SUBJECT: Burk's Falls West Solar Farm - REA #5665-8YFKZU Amendment Application

Subject: Burk's Falls West Solar Project - Proposed Relocation of Stormwater Diversion Channel

Engineering Report
Engineering Management
Modification Document - Proposed Relocation of
Stormwater Diversion Channel

Figure 1-1 & 1-1b

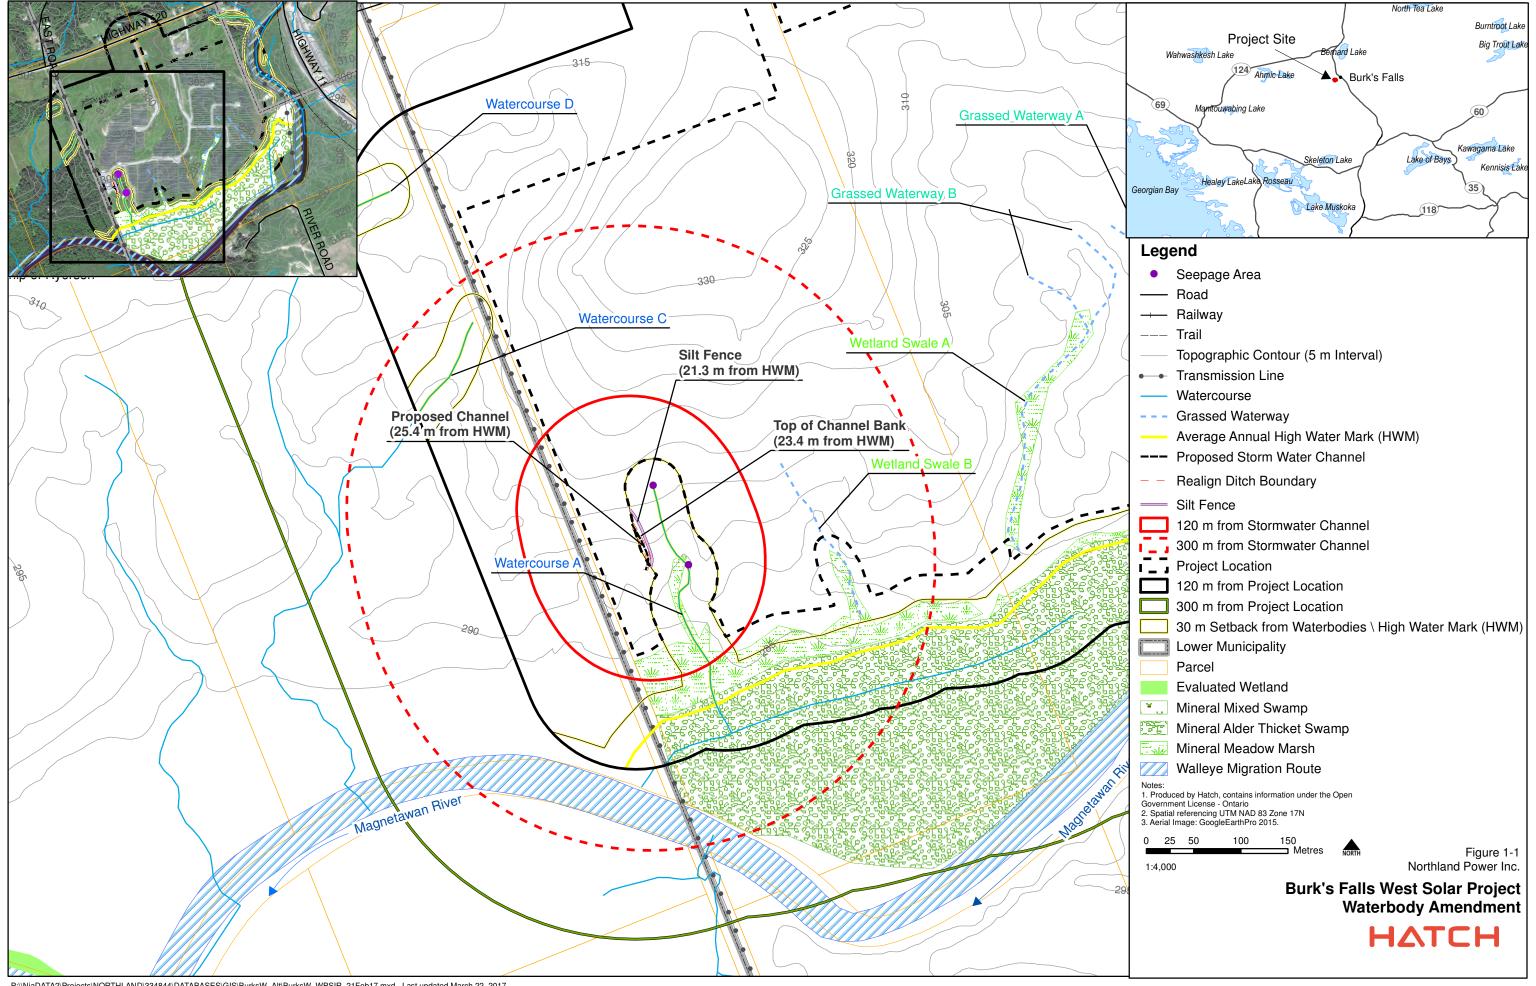
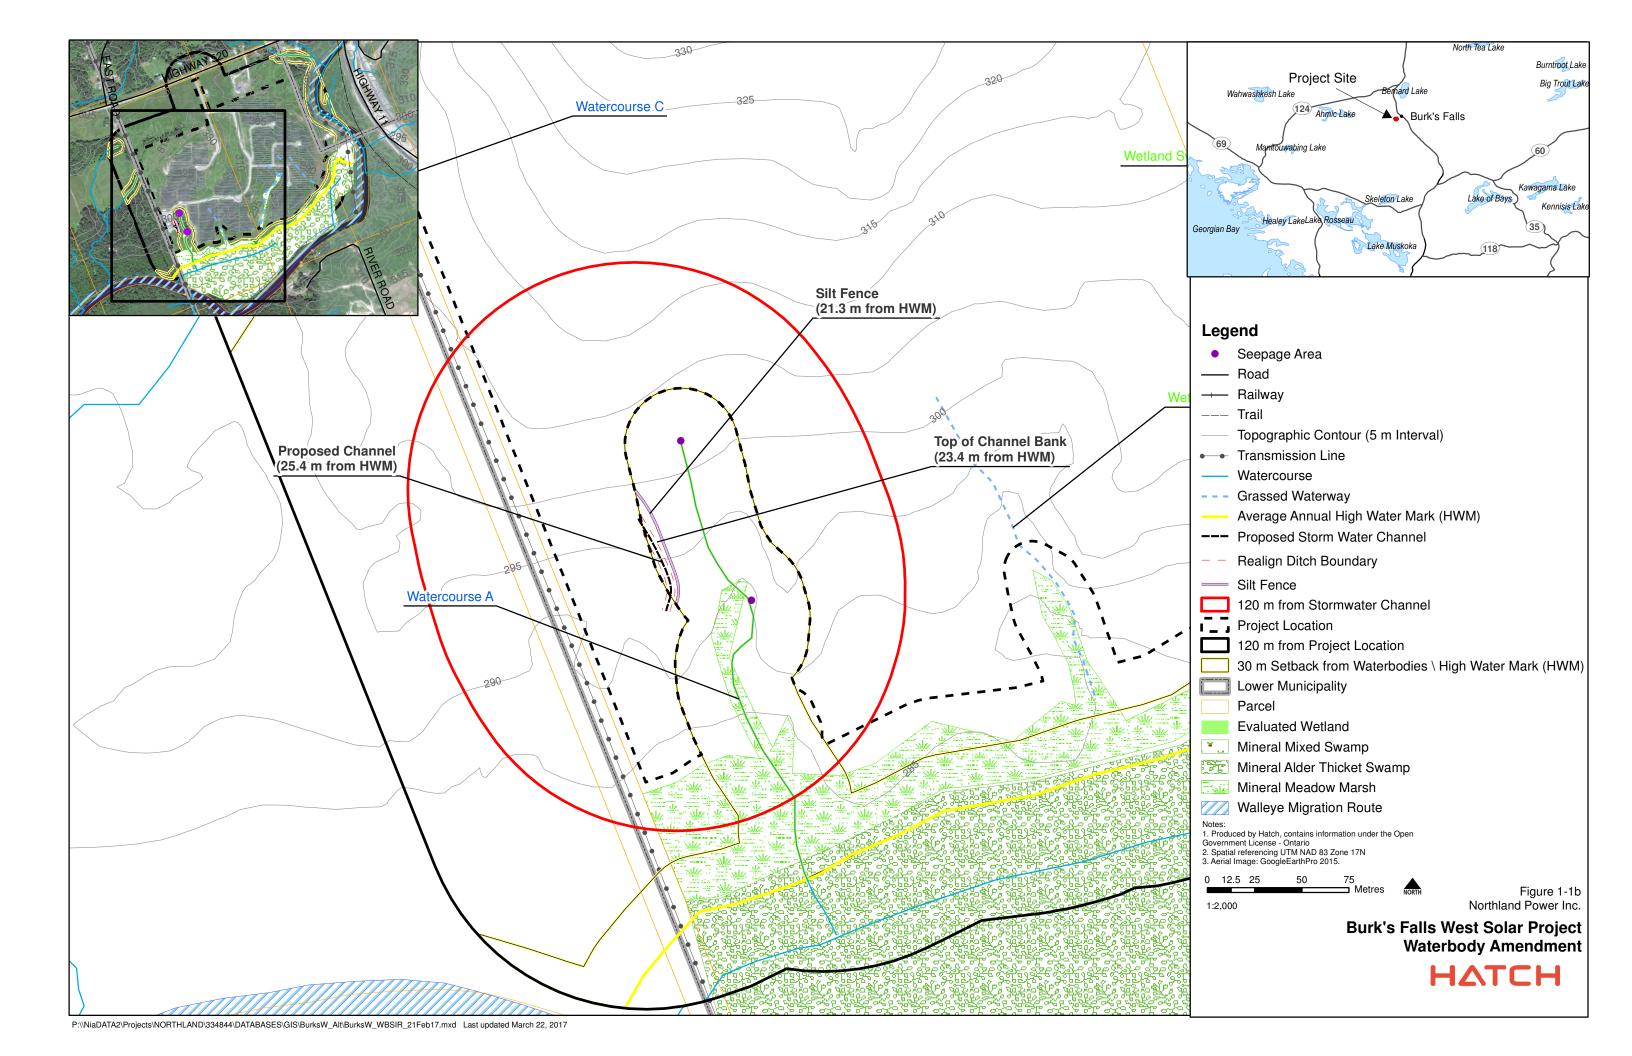
The proposed works would see a reinforcing of the substation retaining walls and the addition of rip-rap stone as extra mass against any unintended movement (all within the approved REA boundary) and the relocation of the perimeter stormwater diversion channel further away from the substation to prevent undercutting. The relocated stormwater diversion channel will be within the 30 m set-back established from a watercourse identified during the 2011/2012 Site Investigations (Figure 1-1). The encroachment into the setback area is proposed to be approximately 6.6 m,

thereby maintaining a 23.4 m setback from the watercourse (Figure 1-1b). To complete the channel, approximately 204 m² of existing soils would be shaped, stabilized with rip/rap stone and revegetated; the discharge is not within a watercourse and as such, sediment or hydrology concerns are mitigated during storm events.
